**ADDENDUM NO. 4**

Date: September 14, 2018  
Project: **Secondary Treatment Plant Upgrade & Recycled Water Expansion**  
Job No.: 12600-07/16650-02

SHEET 148 OF 159	PLAN NO.	DRAWING NO. E-39	REVISION NO. B
---------------------	----------	---------------------	-------------------

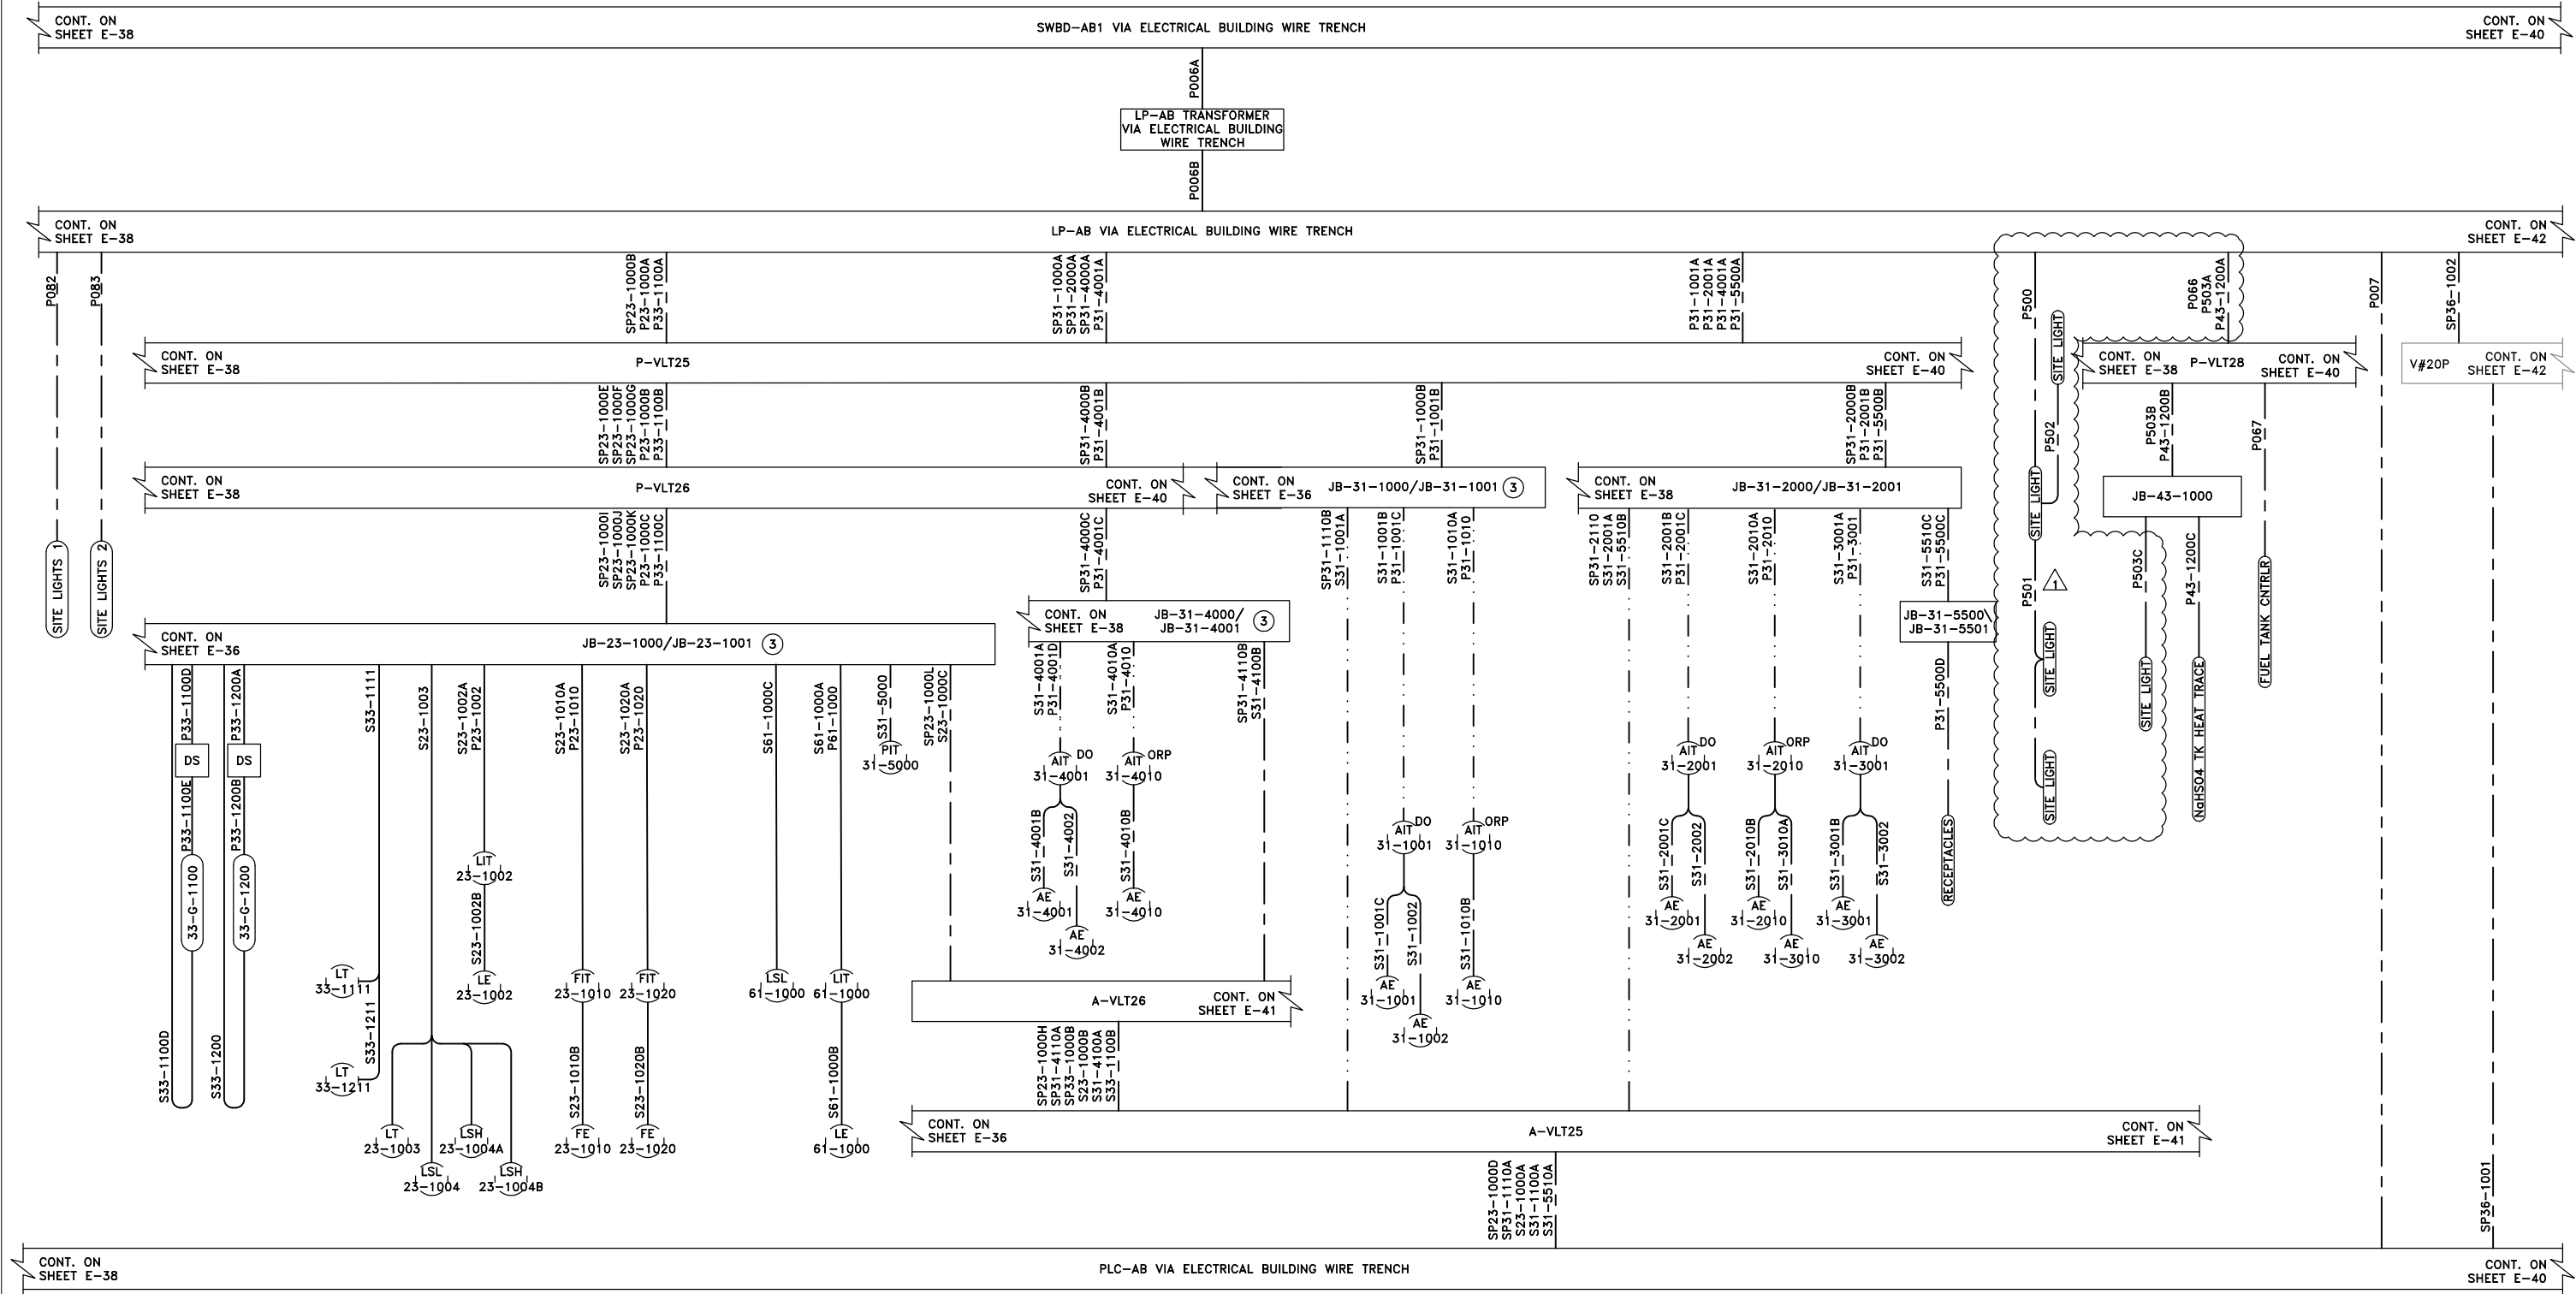
10. **Sheet E-39:** Sheet has been re-issued to show conduits for site lighting.
11. **Sheet E-44, E-45, E-46, E-48, and E-49:** Sheets have been re-issued to show addition to ductbanks for site lighting.
